Chesterfield Cycle Campaign

Response to Chesterfield station HS2 masterplan

February 2021

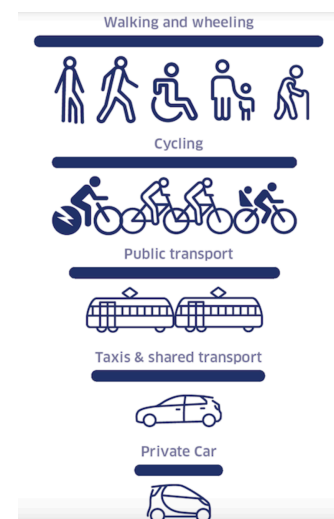
The current segregated cycle/footway that runs from the A61 bridge to the Brewery St Toucan is not shown on any of the drawings. This link needs to be retained and enhanced.
